# Access Compliance Report

## Public Rights-of-Way

### (Curb Ramps)

Intersection ID: 21320	Main Street: FREDERICK_PL	Cross Street: PARK_RD	Location:	SE
ADA ID: EEB4C5ACECBE	Ramp Type: Perp	Initial Pass/Fail: Fail	Overall Compliance: No	Severity Score: 10
Codes/Mitigation Info/Possible Solution		Field Measurements/Component Compliance

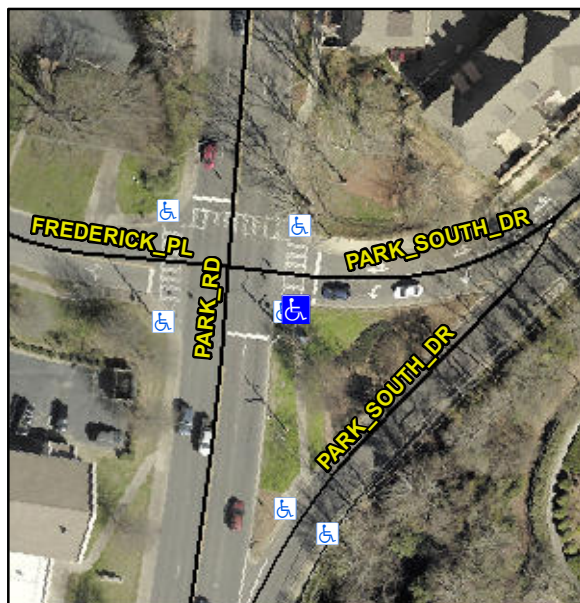
**Not Found, R304.5.1, R304.5.3**

Compliance	Description	Data	Compliance	Description	Data
N/A	Ramp Length (in)	60.0	Yes	Ramp Slope (%)	6.6
No	Ramp Width (in)	45.0	No	Ramp XSlope (%)	2.2
N/A	Flare Type LT	N/A	N/A	Flare Type RT	N/A
N/A	Flare Slope LT (%)	N/A	N/A	Flare Slope RT (%)	N/A
N/A	Flare Traversable LT?	N/A	N/A	Flare Traversable RT?	N/A
N/A	Landing Length (in)	N/A	N/A	DWS Provided?	N/A
N/A	Landing Width (in)	N/A	N/A	DWS Contrast?	N/A
N/A	Landing Slope (%)	N/A	N/A	DWS Length (in)	N/A
N/A	Landing X Slope (%)	N/A	N/A	DWS Full Width?	N/A
N/A	Landing Curb? (Y/N)	N/A	N/A	DWS Offset (in)	N/A
N/A	Shared Landing?	N/A			
N/A	Gutter Ponding?	N/A	N/A	Gutter Slope (%)	N/A
N/A	Gutter Lip Ht (in)	N/A	N/A	Gutter X Slope (%)	N/A
N/A	Painted X Walk1?	Yes	N/A	Painted X Walk2?	N/A
	X Walk 1 Direction	To NE		X Walk 2 Direction	N/A
N/A	X Walk 1 Width (in)	112.0	N/A	X Walk 2 Width (in)	N/A
	X Walk 1 Slope (%)	0.0		X Walk 2 Slope (%)	N/A
	X Walk 1 X Slope (%)	1.2		X Walk 2 X Slope (%)	N/A

**Remove & Replace Entire Ramp.**
